Re: 14CVCP181K
200 Water Street
Brooklyn, NY
Remedial Action Work Plan (RAWP) Stipulation List

Cardno ATC (the consultant) hereby submits a Remedial Action Work Plan (RAWP) Stipulation List for the 200 Water Street (the Site) to the New York City Office of Environmental Remediation (OER) on behalf of Dumbo Assemblage LLC. This letter serves as an addendum to the RAWP to stipulate additional content, requirements, and procedures that will be followed during the Site remediation. The contents of this list are added to the RAWP and will supersede the content in the RAWP where there is a conflict in purpose or intent. The additional requirements/procedures include the following Stipulation List below:

DRAWING TITLE:
**EXTENT OF SOIL EXCAVATION AND
 END-POINT SOIL SAMPLING LOCATIONS**

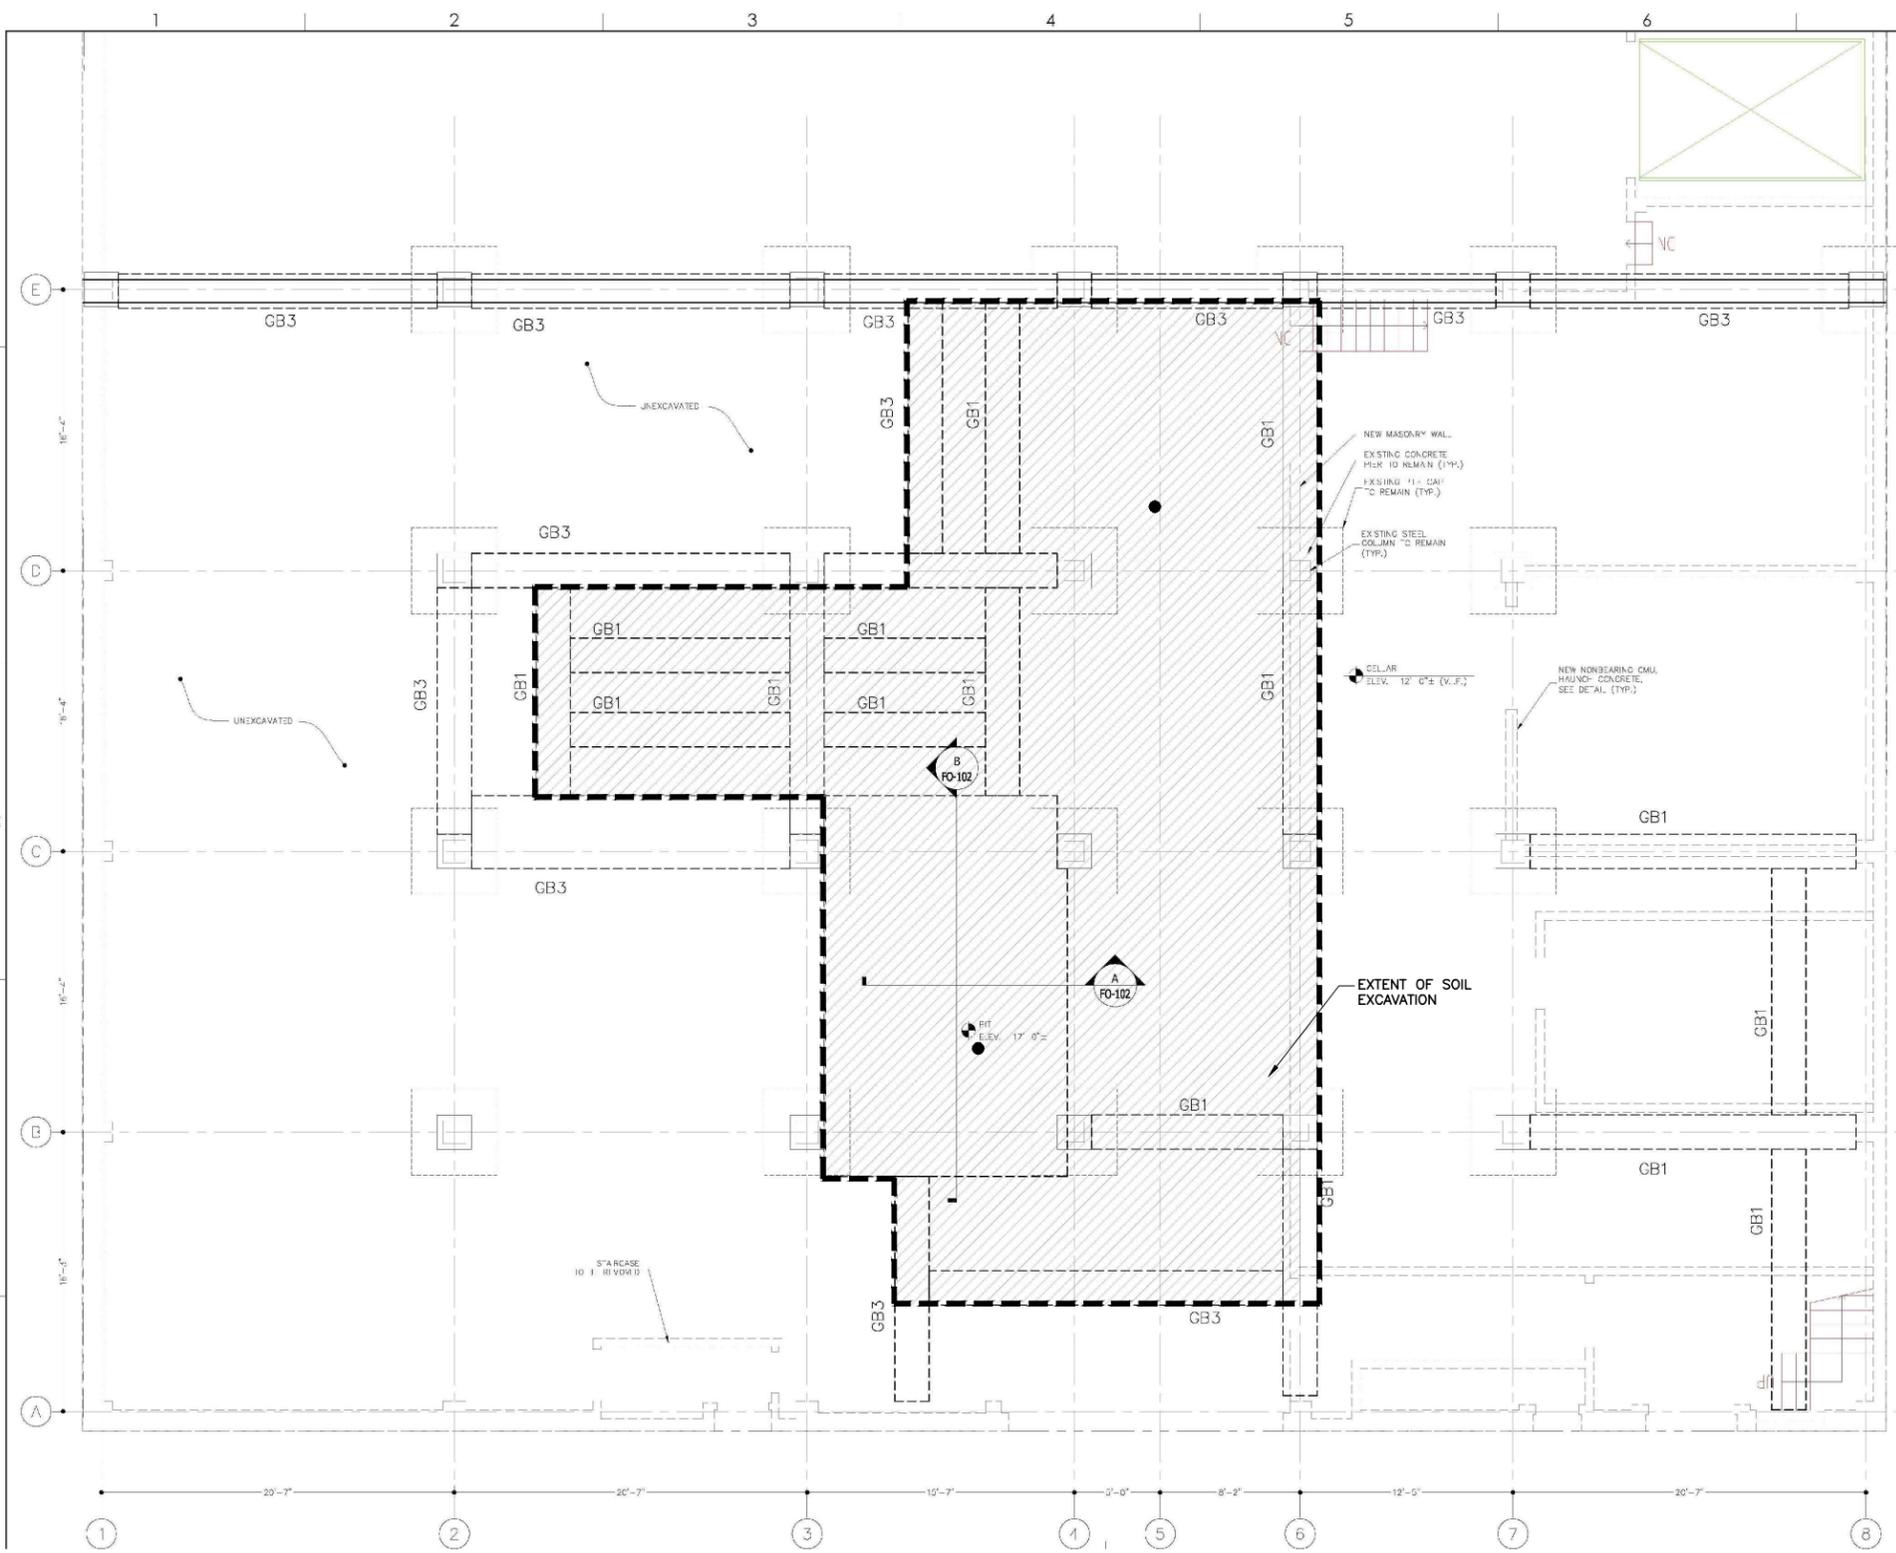
7. Collection and analysis of two post-excavation samples from the bottom of the excavation will be collected to evaluate the performance of the remedy with respect to attainment of Track 4 Site Specific SCOs. Figure 6 indicating End point post-excavation sampling locations is attached in **Appendix 3**. Samples will be analyzed for contaminants of concern (SVOCs and metals).

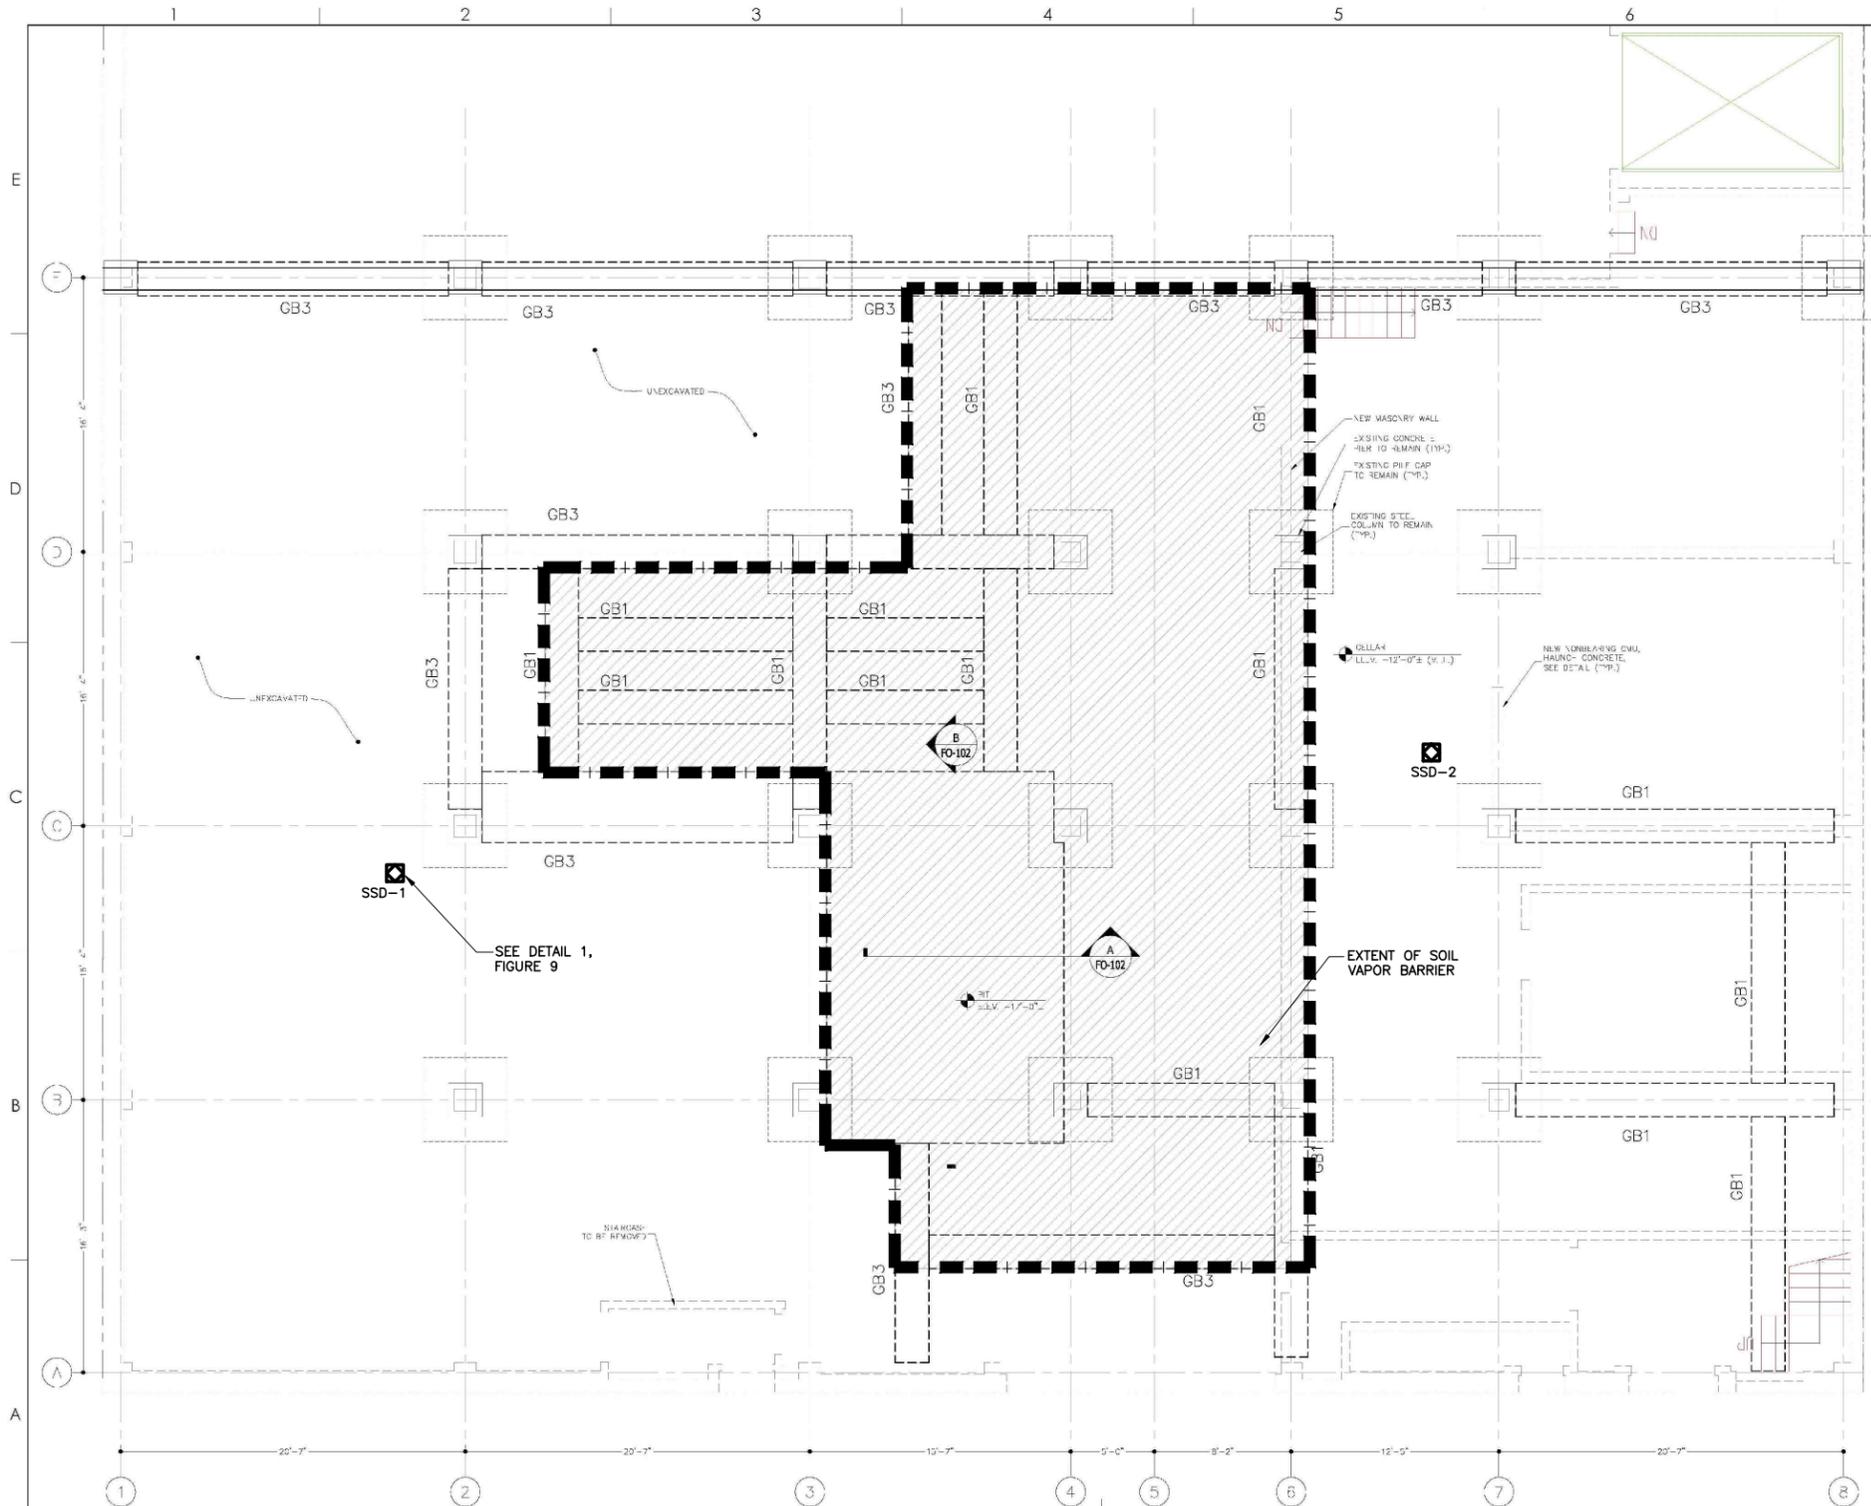
10. **Appendix 6** includes design plans for an active Soil Vapor Extraction System beneath the concrete basement floor of the proposed building;
11. OER requires parties seeking City Brownfield Incentive Grants to carry insurance. For a cleanup grant, both the excavator and the trucking firm(s) that handle removal of soil must carry or be covered under a commercial general liability (CGL) policy that provides \$1 million per claim in coverage. OER recommends that excavators and truckers also carry contractors pollution liability (CPL) coverage, also providing \$1 million per claim in coverage. The CGL policy, and the CPL policy if obtained, must name the City of New York, the NYC Economic Development Corporation, and Brownfield Redevelopment Solutions as additional insured. For an investigation grant, an environmental consultant must be a qualified vendor in the BIG program and carry \$1 million of professional liability (PL) coverage. A fact sheet regarding insurance is attached as **Appendix 7**.

Since volatile organic compounds (VOCs) were measured in the soil vapor beneath the basement slab, an active sub-slab depressurization system (SSDS) will be installed at 200 Water Street. The SSDS will be constructed as an engineering control to mitigate potential vapor intrusion hazards associated with the VOCs. The SSDS shall be installed as outlined below.

1. The SSDS will be comprised of two suction pits (Figure 8) to draw soil vapor to a roof mounted blower where the vapors will be discharged to the atmosphere.

2. General air flow requirements for the SSDS system is based on the volume of sub-slab pore space that is affected, which is based on an building footprint of 6,714 square feet, a depth of influence of 3.5 feet, and four air changes of the pore space per day.

3. Each SSDS pit will consist of an approximate 3 feet wide x 3 feet long x 3 feet deep pit excavated beneath the existing basement floor. A 4-inch Schedule 40 PVC pipe, covered with a galvanized wire mesh screen will be place within the pit and the surface sealed with concrete.

DRAWING TITLE:
**DEPRESSURIZATION SYSTEM
DETAILS**
SCALE:
N.T.S.
ATC PROJECT: # 15.44291.0004

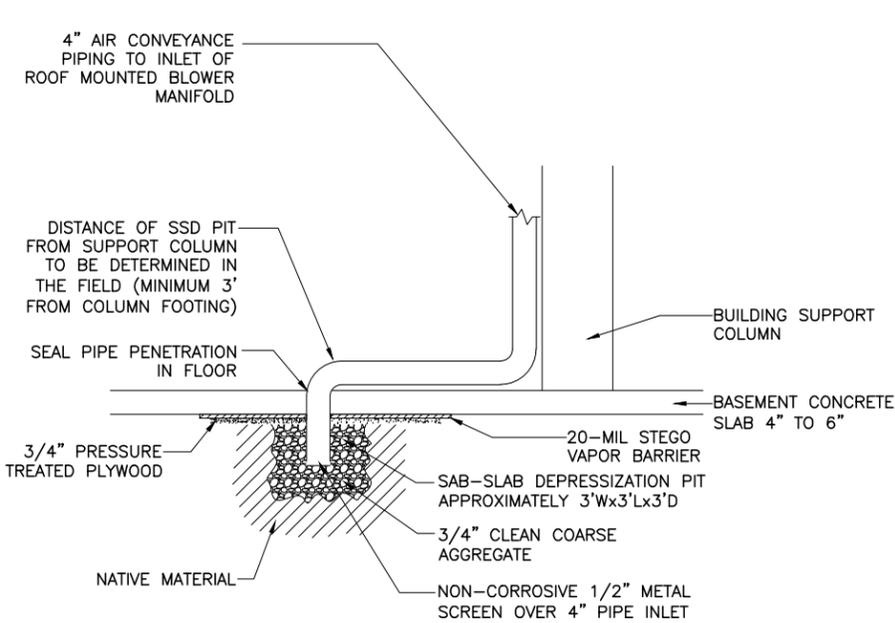
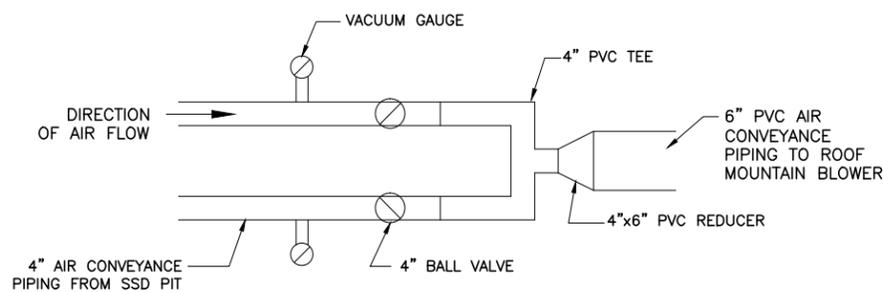
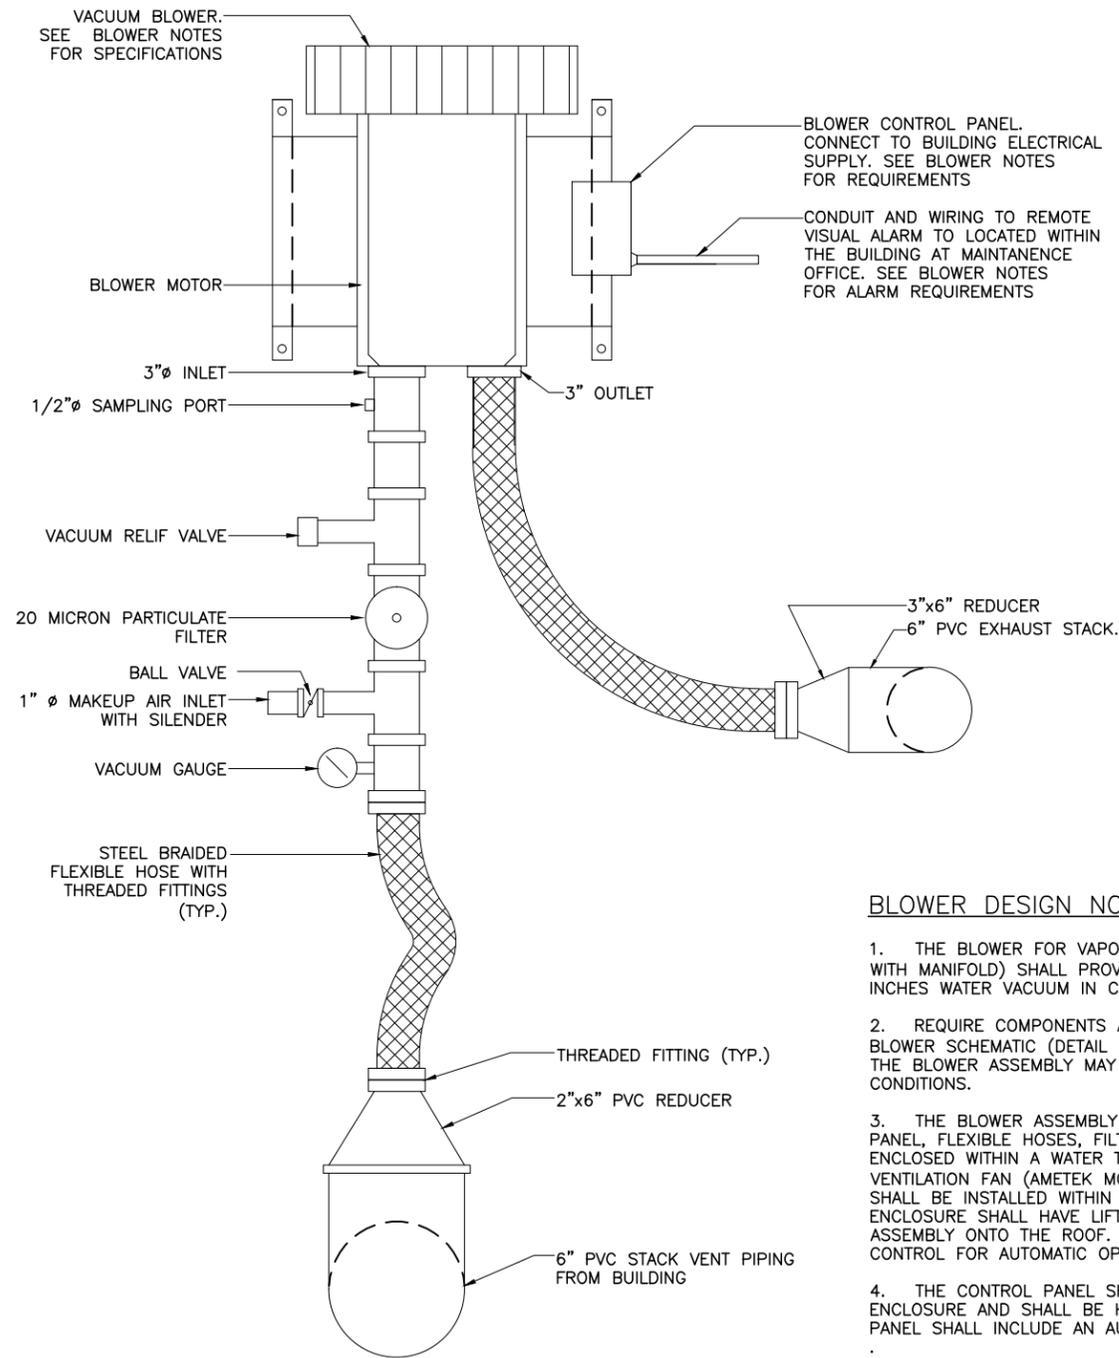
5. The calculated required vacuum for the system is based on a required sub-slab vent inlet vacuum pressure loss of 20 inches water column (WC), piping and valve losses of 10 inches WC, filter losses of 7 inches WC, and silencer losses of 6 inches WC, for a combined required vacuum at the blower inlet of 43 inches WC. Given the above design requirements, the vacuum blower for SSD pits 1 and 2 (combined with a manifold system) should provide a minimum flow rate of 100 cubic feet per minute (cfm) at a vacuum of 45 inches WC (Figure 9).

- THE BLOWER FOR VAPOR EXTRACTION PITS SSD-1 AND SSD-2 (COMBINED WITH MANIFOLD) SHALL PROVIDE A MINIMUM AIR FLOW RATE OF 100 CFM AT 45 INCHES WATER VACUUM IN CONTINUOUS OPERATION AT THE BLOWER INLET.
